**TOWN OF ERIE
BOARD OF TRUSTEES
March 12, 2019**

SUBJECT: Dearmin Sketch Plan No. 2 - A Sketch Plan represents a generalized land use plan and layout for the area proposed to be included within a subdivision. A Sketch Plan application is required to allow for an early, informal evaluation of a proposed subdivision before detailed planning and engineering work has occurred.

PURPOSE: Board of Trustees review and comment on a Sketch Plan application for 946 dwelling units and 35,000 sq. ft. of non-residential/commercial space.

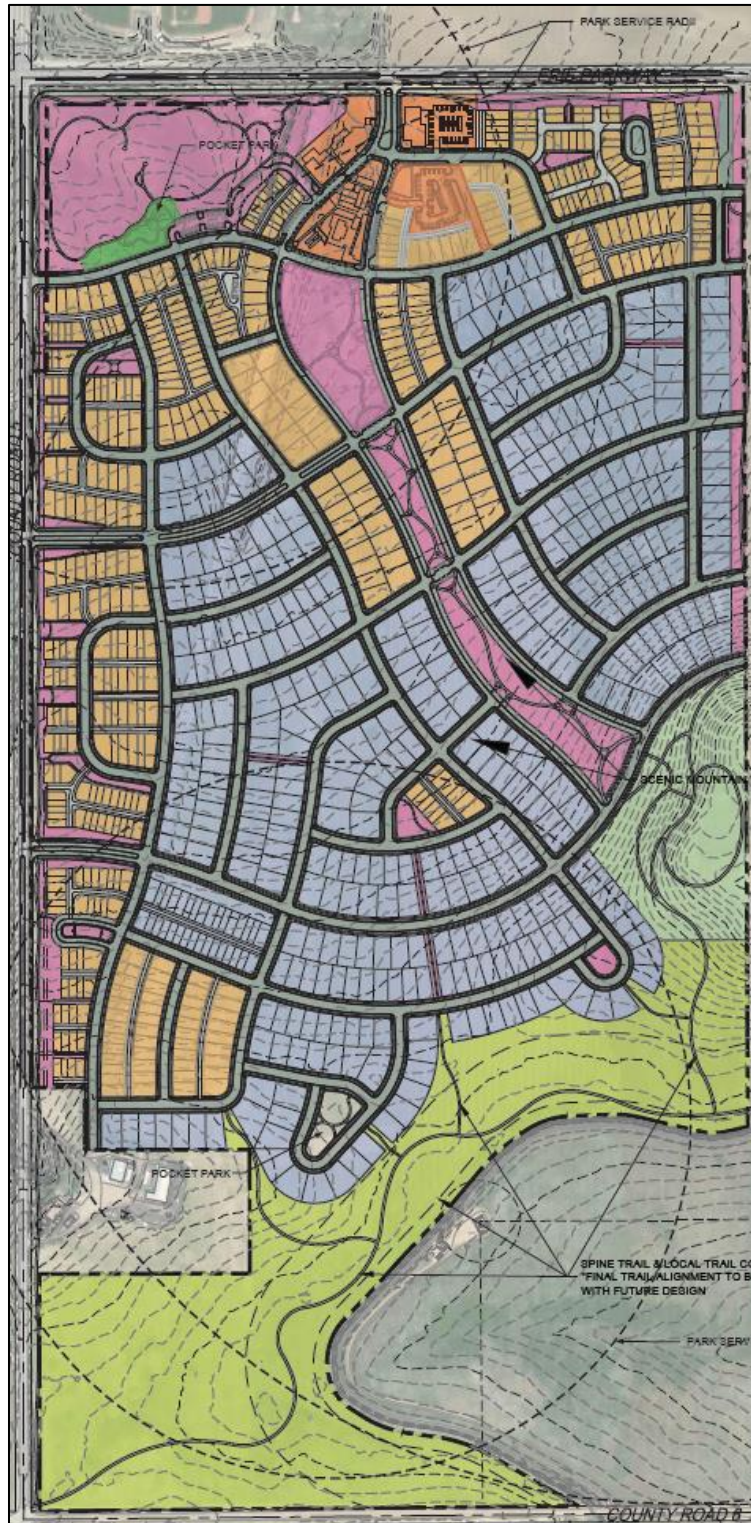
The Land Use Plan Map identifies, with a green flag, a future school site partially on the Dearmin Property. The sketch plan anticipates the required school site will be provided on the adjacent property.

Erie Parkway is shown with a cross hatched pattern over it to designate this transportation corridor as an “Area of Special Consideration”. These Areas of Special Consideration are identified to acknowledge their importance as a major community gateway and that an increased level of review and consideration should be placed on development proposal occurring within the areas identified, in terms of their uses and design. The sketch plan provides room for the required 30 foot buffer and further development review processes will address the other treatments such as development orientation, parking screening, and landscaping.
